PERMIT

SEWAGE DISPOSAL SYSTEM

MARYLAND STATE DEPARTMENT OF HEALTH

SUBDIVISION Moorefield ROAD _____ LOT 14, Blk. A, Plat 3

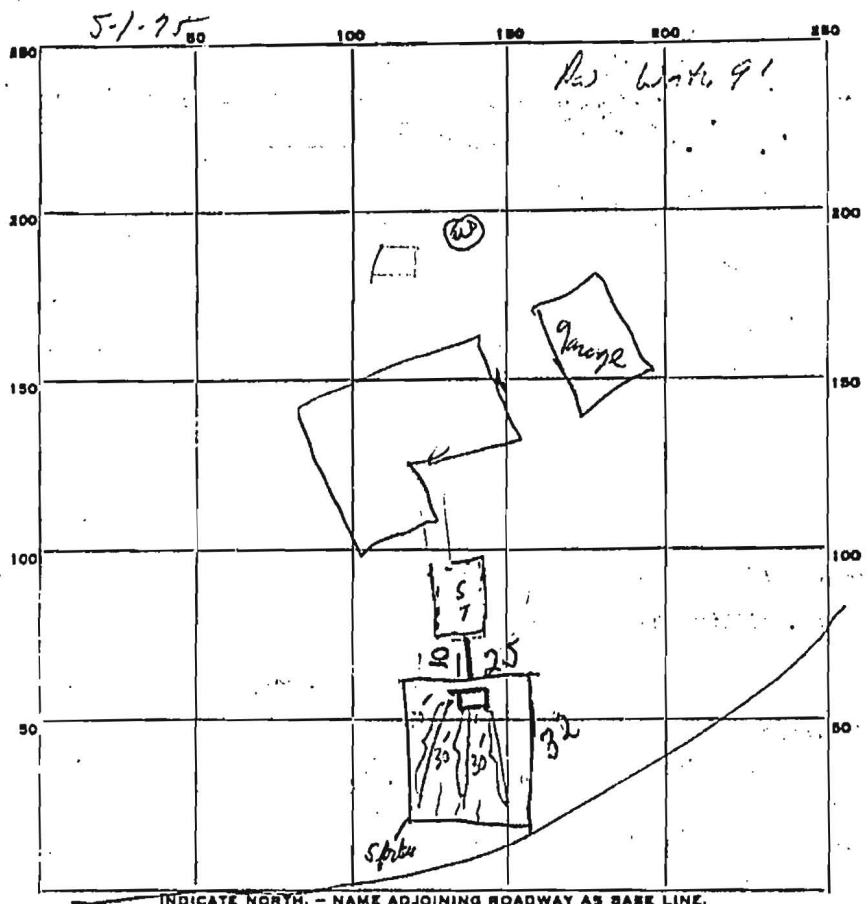
REMARKS ⁵⁻⁵⁻⁷⁸ Mount 7. 2' deep - ok to put gravel in bed. ^{5/9/78} 110

III. BOX IN STALLGD - PUT STONE IN BED & CALLS R.H.

5/9/78: Not Ready needs more gravel. must cover enough
 gravel over pipe in the trench. Also need to have
 a cleanout on Septic Tank CMB.

5/11/78 As Per Conversation Mr. Monahan okay to backfill over leaching bed and install
 cleanout on Septic Tank CMB.
